TECHNICAL NOTE: 0542018_DD002

TO: Steve Jones
FROM: Jordan Mayes
SUBJECT: 14-16 Regent Road, Wrexham: Separating Floors
DATE: 05 June 2018

This Design Development Note (DDN) provides comment on the proposed separating floor constructions with regards their ability to meet the sound insulation performance requirements outlined in Approved Document E of the Building Regulations.

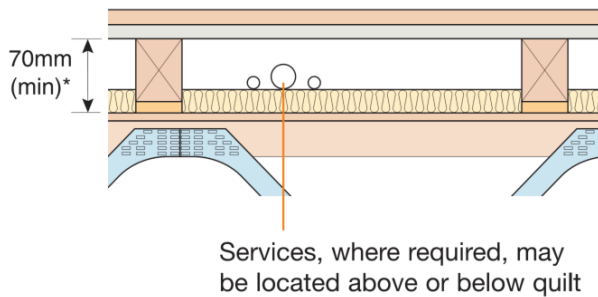
The proposed new-build timber separating floors are sufficient to meet the sound insulation performance requirements outlined in Table 1. In terms of value engineering, the following amendments could be made without compromising the suitability of the system:

- The Gypsum-based board below the 18mm tongue and groove flooring board on top of the floating timber floor battens can be amended from 15mm Gyproc Soundbloc Board to 12.5mm wallboard throughout.
- The ceiling to the ground floor retail units and first floor apartments could be substituted from 2 x 15mm Gyproc Soundblock Board to 2 x 12.5mm Gyproc Wallboard.

It is important that a flanking strip is included to isolate the floating floor from the surrounding structure, as indicated below. The skirting board should sit on-top of the folded flanking strip as identified in the figure.

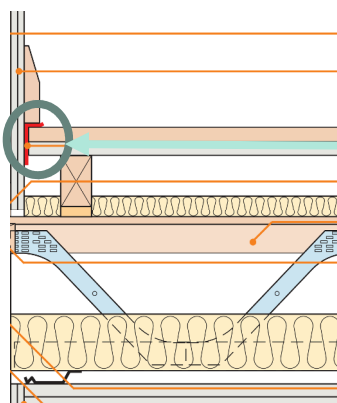
At level 1 the concrete floor will separate the Bedroom of Apartment 2 and retail space below. At level 2 the concrete deck will separate Bedroom 1 of Apartment 2 and Bedroom 1 of Apartment 4. As such, the separation should meet the sound insulation performance outlined in Table 1.

In addition, the ceilings below the concrete deck should include the following:

- 1 x 15mm Gyproc Wallboard layer suspended below concrete floor from a lightweight steel grid with 50mm Rockwool (33kg/m³) in void. The void depth can be controlled to match adjacent ceiling depth but should be at least 100mm.

Figure 1 - SoundDeck overlay Acoustic Floor Boards

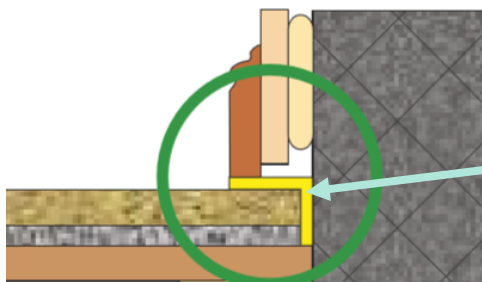
To control impact sound transmission we recommended a tongue and groove flooring board with a pre-bonded resilient backing is installed on top of the screed.

A suitable system is the [SoundDeck overlay Acoustic Floor Boards](#) by CMS Danskin (or similar). The selected system should achieve an impact sound insulation performance not less than $\Delta 17$ dB. The CMS Danskin system referenced above is 26mm thick and the floor finish can be applied directly to the floor boards.

Again, it is important that a flanking strip (Yelofon FS or similar) is used to maintain the isolation of the floating floor system, as identified in principle below.
